Heritage Council Registrations and Reviews Committee

Her Majesty's Prison Pentridge, 1 Champ Street, Coburg

Hearing – 1 April 2019 **Members** – Mr Patrick Doyle (Chair), Ms Natica Schmeder, Ms Maggi Solly

DETERMINATION OF THE HERITAGE COUNCIL

MAP SHOWING APPROXIMATE LOCATION OF VIEWLINE

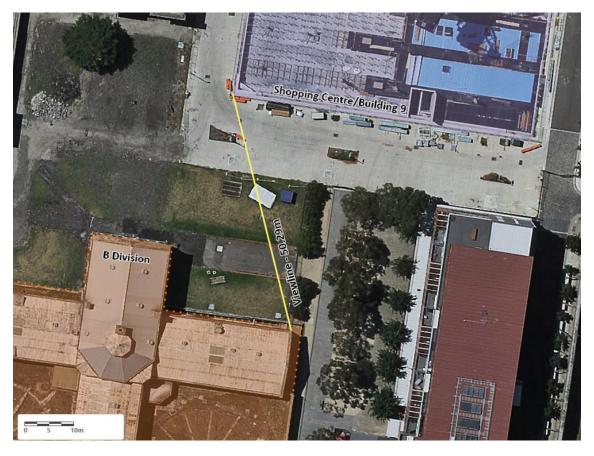
- **070.** The Committee considers that the adverse impact on views of B Division from the west and north could be mitigated in various ways. One way may involve reorienting the building, and siting it somewhat further east, to provide an uninterrupted view of B Division from the point where Sentry Lane and Road D intersect ('Viewline'). The approximate location of this Viewline is shown on **Attachment 1** and extends from the south-eastern corner of Building 9 to the north-eastern corner of the eastern wing of B Division.
